Addendum Number: Three **Architect's Project #:**

**Project Name:** CN Catoosa Child

**Development Center**

From: BLUE RIVER ARCHITECTS,

**FIRST FLOOR** PLAN - AREA A

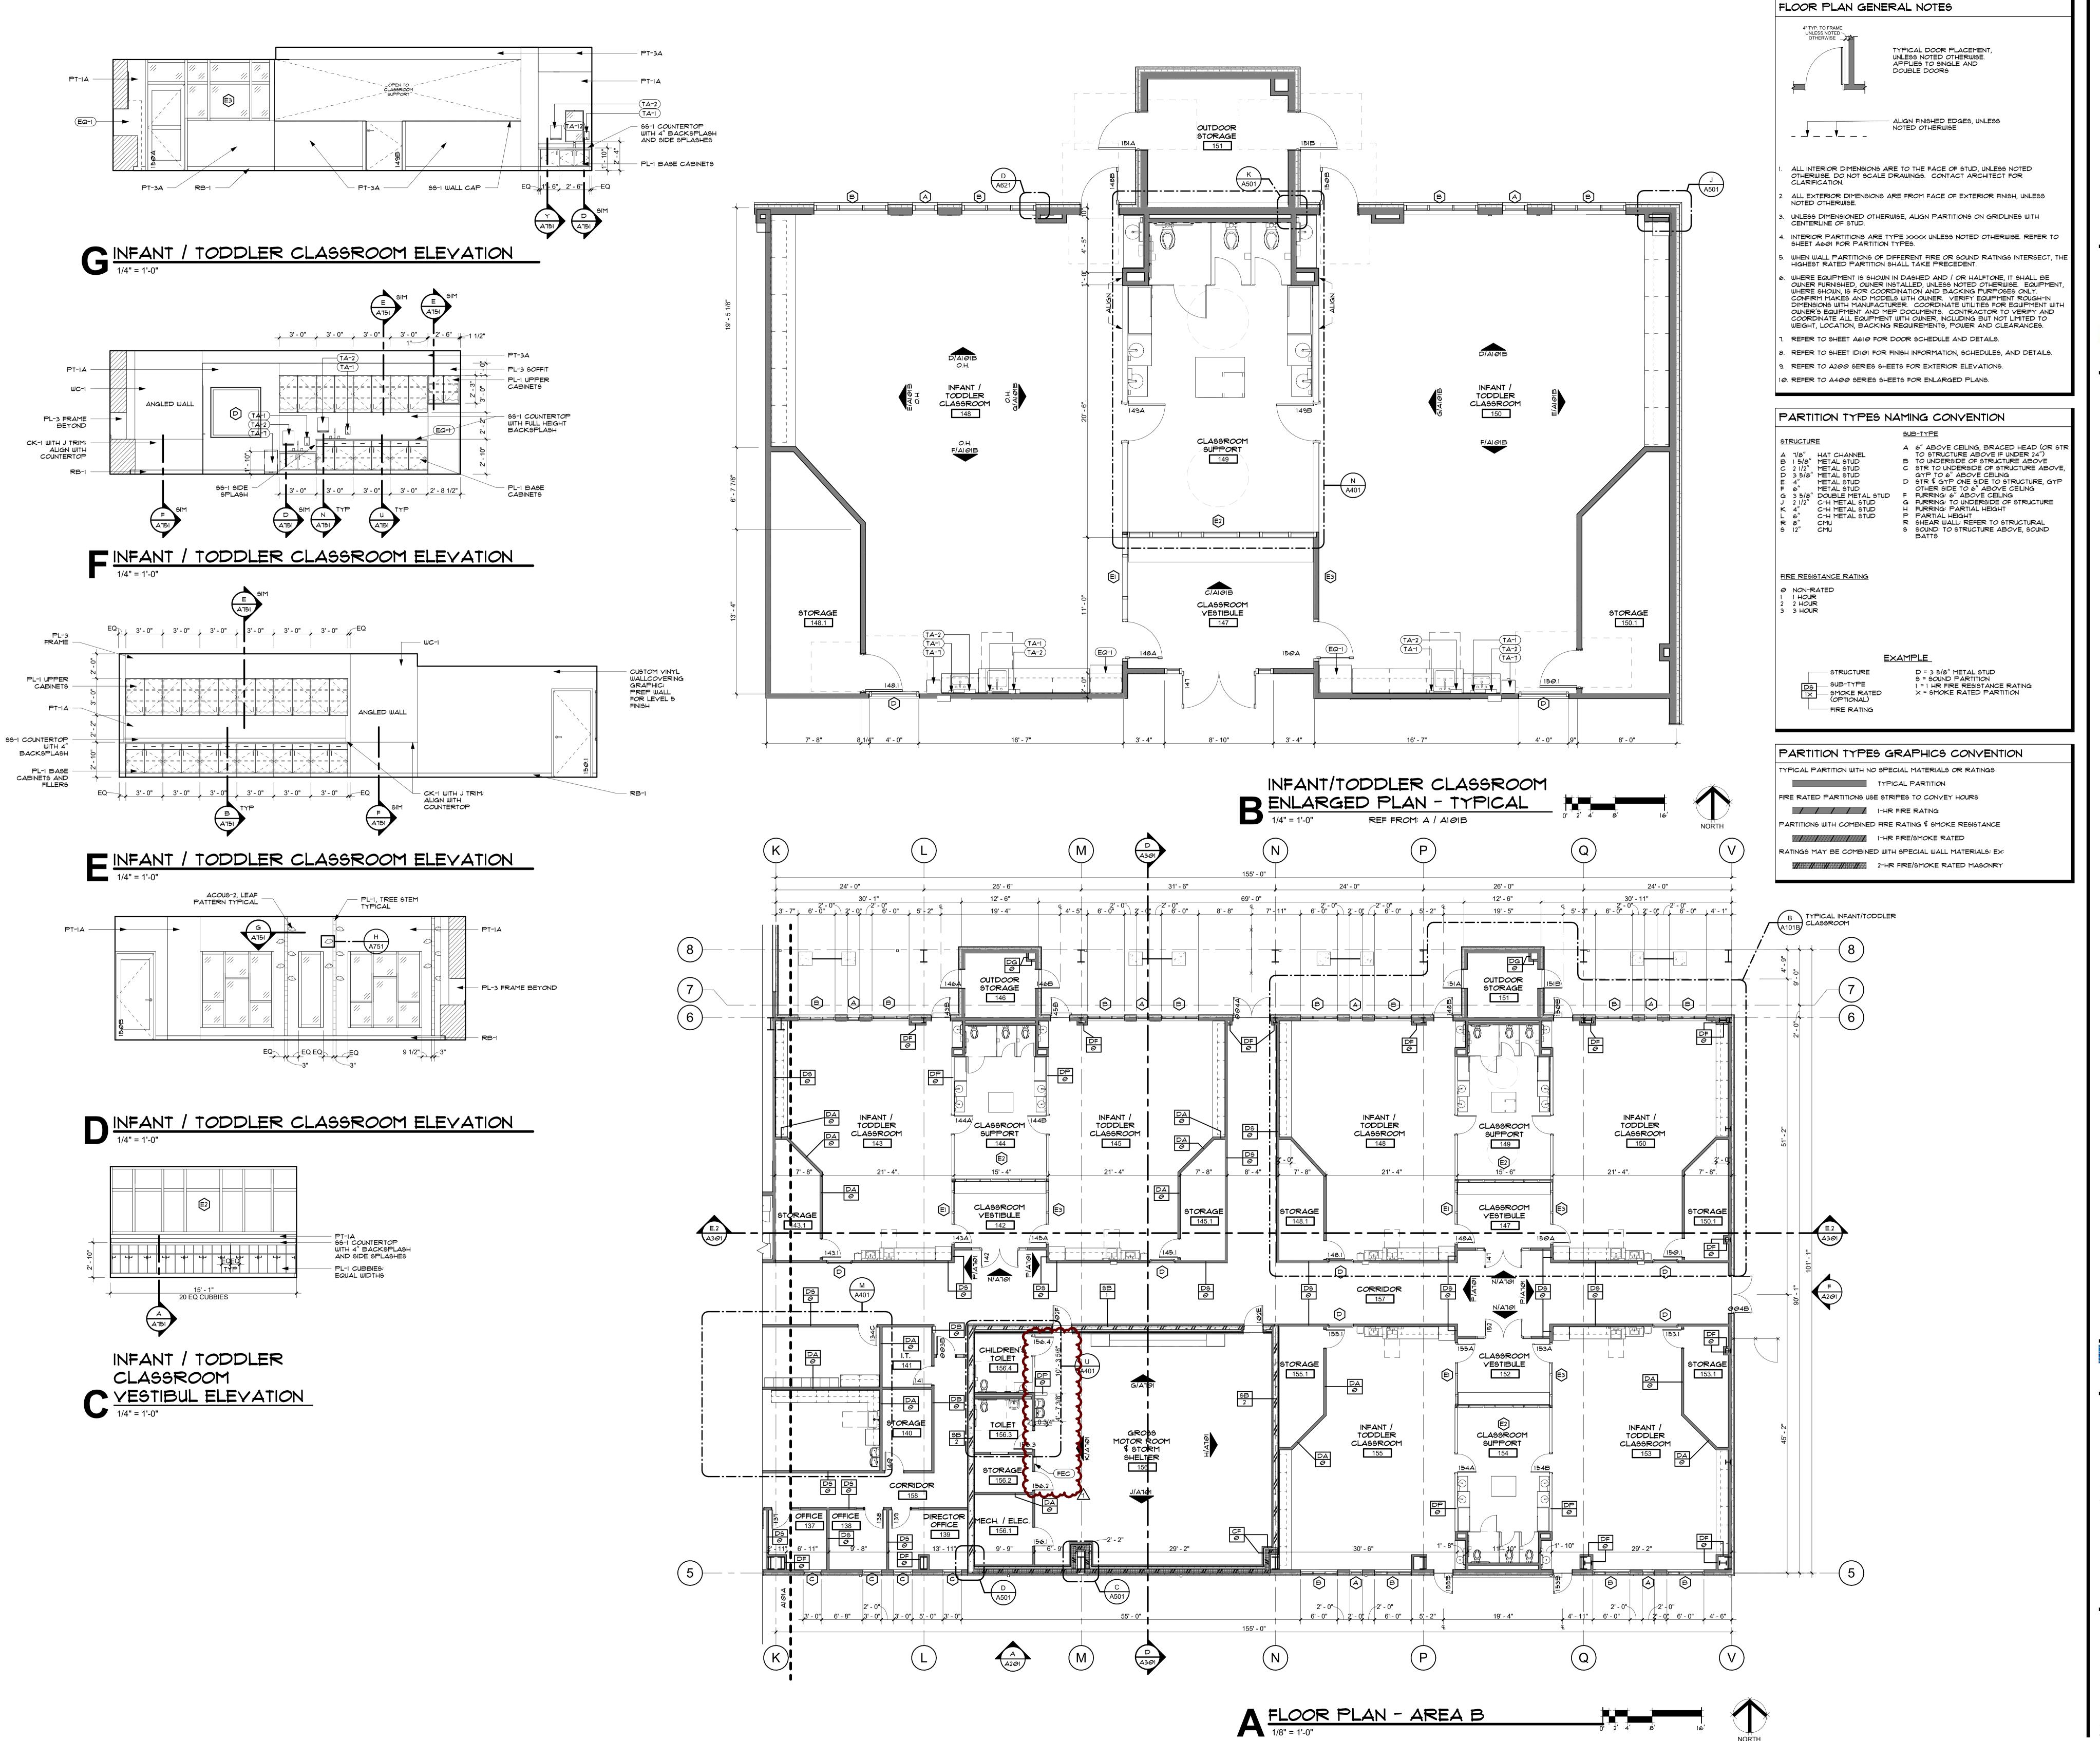
- 27. A101A First Floor Plan Area A
  - 27.1 Relocated drinking fountain.
  - 27.2 Added wing walls at drinking fountain locations.
- 28. A101B First Floor Plan Area B
  - 28.1 Relocated drinking fountain and fire extinguisher cabinet.
- 29. A111 Roof Plan
  - 29.1 Added roof section detail callout.
- 30. A112 Roof Details
  - 30.1 Added roof detail K/A112.
  - Add graphic for insulation where wall terminates at roof system for details A/, B/, D/, and F/, and G/A311.
- 31.A311 Wall Sections
  - 31.1 Updated furring channel depths.
  - 31.2 Add graphic for air and vapor barrier on E/A311.

ROOF DETAILS

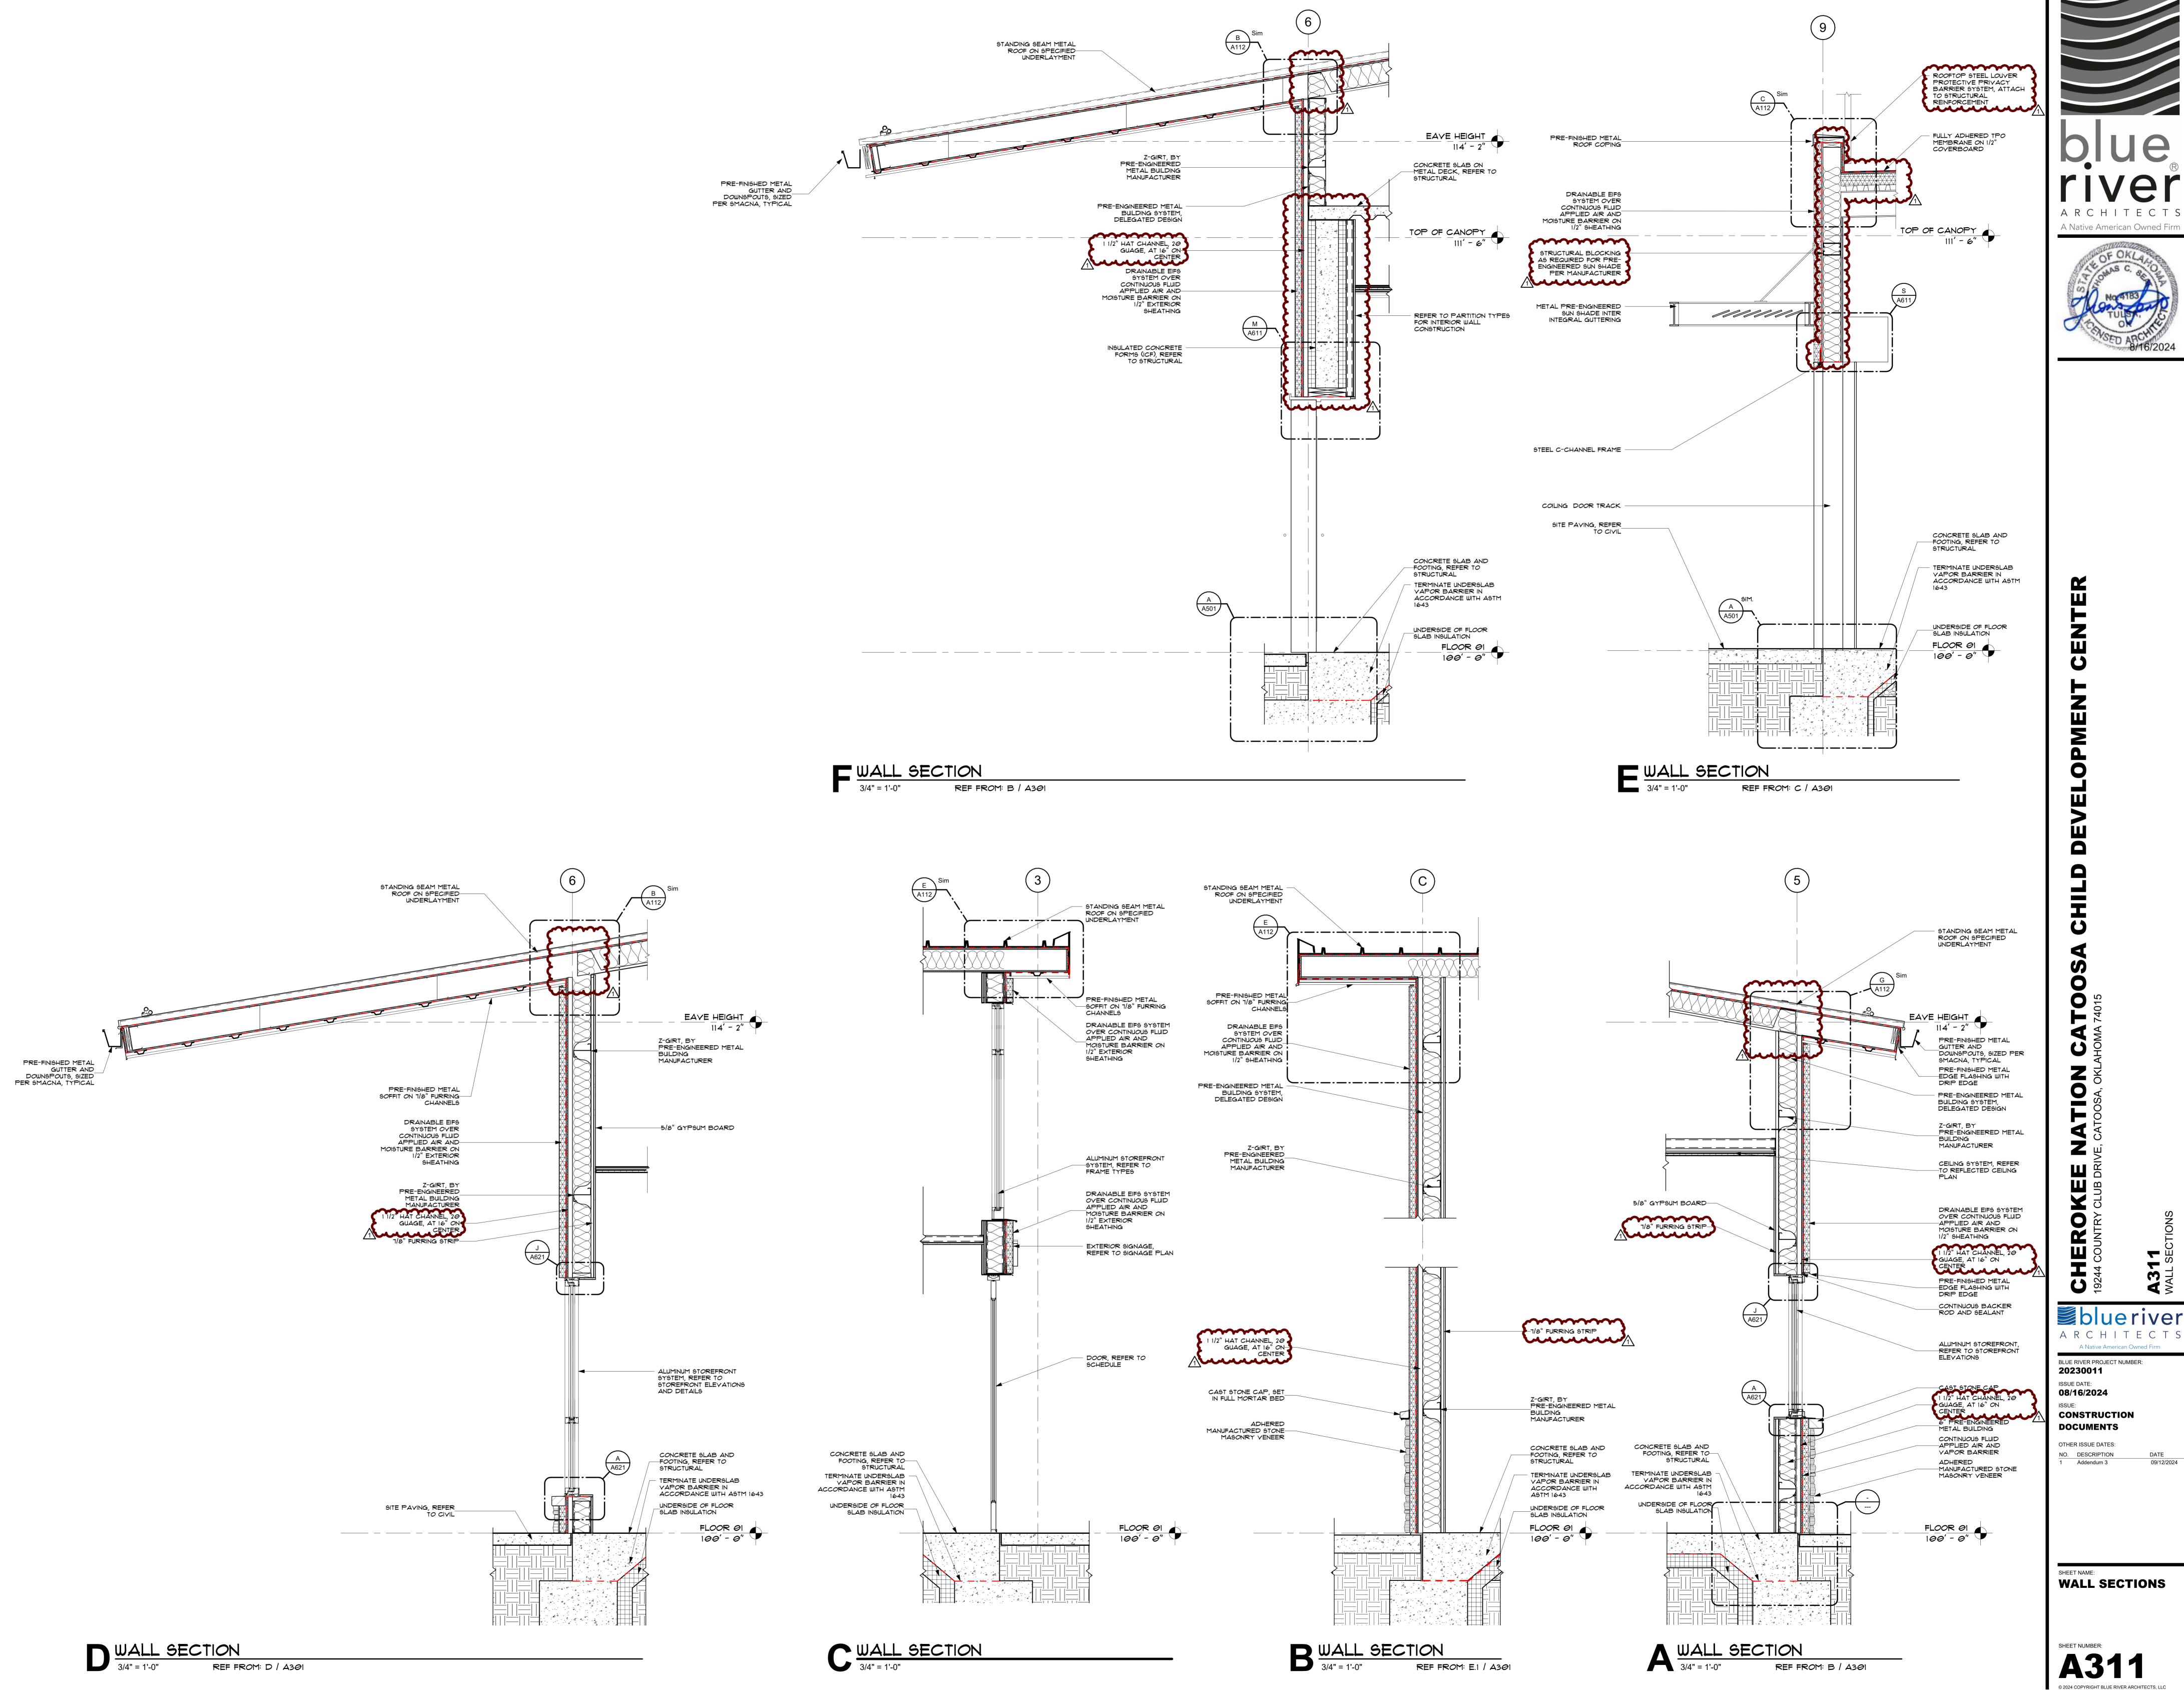
20. <u>Pre-Bid RFI 32:</u> We wanted to get clarification on the Drive thru Canopy on the South end of the Building. Will there be any 7/8" Hat channel or stud framing involved?

- 21. <u>Pre-Bid RFI 33:</u> Can you provide a cut section thru the drive canopy? <u>Answer:</u> Please see attached new detail K/A112 for drive canopy.
- 22. <a href="Pre-Bid RFI 34">Pre-Bid RFI 34</a>: On #4 of the Structural fill requirements, page 18, of Geo Report it states that onsite soils can possibly be used for building and pavement fill areas providing they remain 4 ft and 1 ft below subgrade? The Geo report also states that the building should have 24" undercut and approved structural fill placed prior to aggregate base course and concrete, and roadways are to have 10" of undercut and structural fill placed prior to agg base and perspective paving type? Could clarity be given to the use of onsite fills for building and driveway fill areas?

<u>Answer:</u> Please see attached new detail K/A112 for drive canopy. Note that additional framing will be required at lighting locations as needed to support fixture installation.
